Subject: Notice of Negative Declaration for the Construction of Wall and Drainage
Improvements in the Ailuna/Leighton Street Area, Honolulu, Oahu, Hawaii,
Tax Map Key: 3-6-04

NOTICE OF NEGATIVE DECLARATION
FOR THE
CONSTRUCTION OF WALL AND DRAINAGE IMPROVEMENTS
IN THE AILUNA/LEIGHTON STREET AREA
CITY AND COUNTY OF HONOLULU, OAHU, HAWAII

APPENDIX D
COMMENTS

APPENDIX C
TYPICAL SECTION
SCALE: 1/4" = 1'-0"

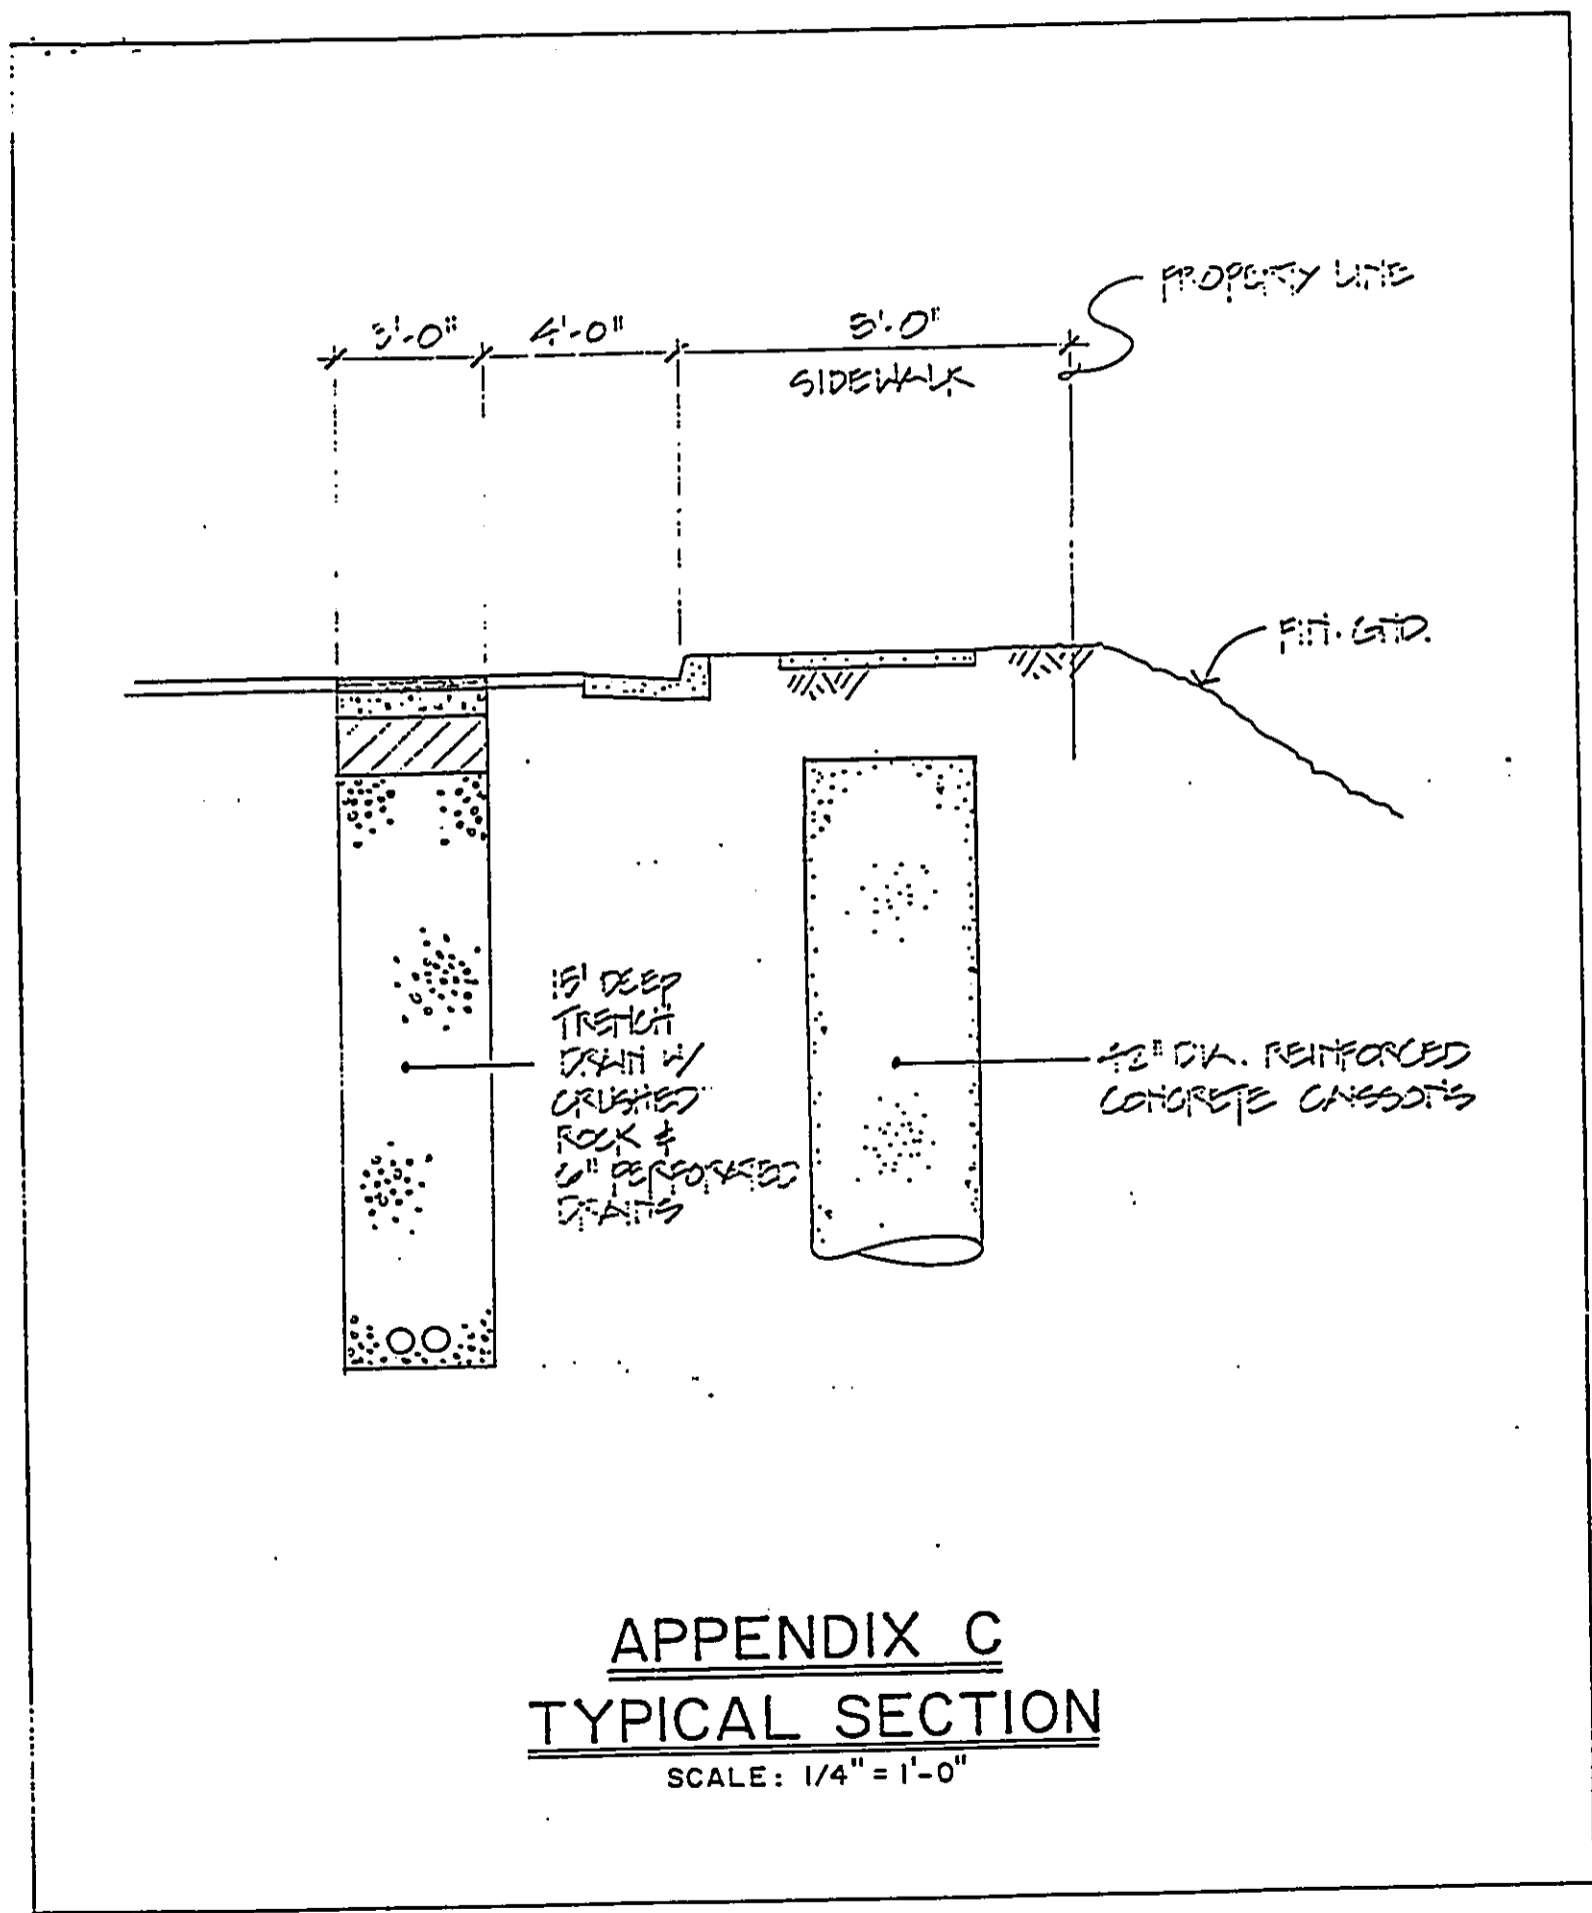
1. The concrete section of the sidewalk, as shown in Appendix C, should abut the property line. Guardrails should be provided, if necessary.
2. Construction plans for all work within the City's right-of-way should be submitted to our department for review. A traffic control plan showing temporary detours for pedestrians and vehicles should be included in these plans.
